MSW Comments on Bowdens Response to  
Submissions and the Proposed Amendment  
(Michael White, March 2022)

# MSW Comments on Bowden's Response To Submissions Report and the Proposed Amendment

Figure 18. The median performance rises from Worldwide Hydraulic Excavator Annual Unit Production (t/CuM of Capacity) 2003-2010 by Performance

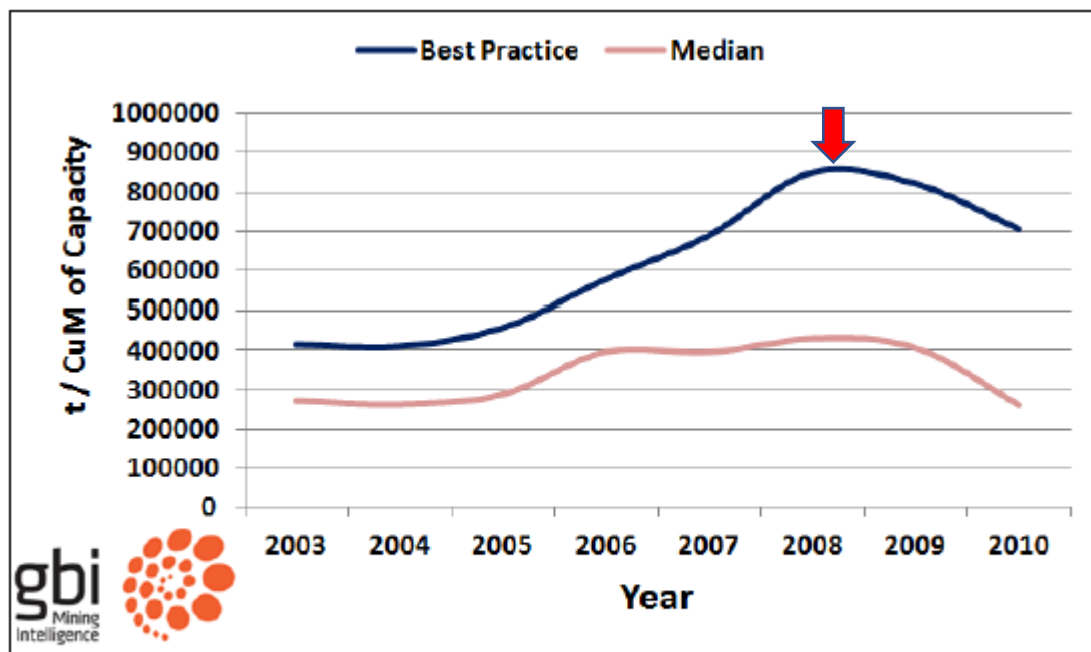
Shown below is an extract from a paper published in 2012 by Dr Graeme Lumley<sup>5</sup> of GBI Mining Intelligence (now part of PwC) showing worldwide performance of excavators in tonnes per cubic metre of bucket capacity.

If one uses the 2008 world's best practice highest value of 850,000 tonnes per cubic metre and applies this to a 12 cubic metre bucket the annual capacity for the world's best 190 tonne excavator is **10.2 million tonnes per annum.**

Bowden's state 19.35 million tonnes per annum which is almost twice the output of the world's best performing excavators.
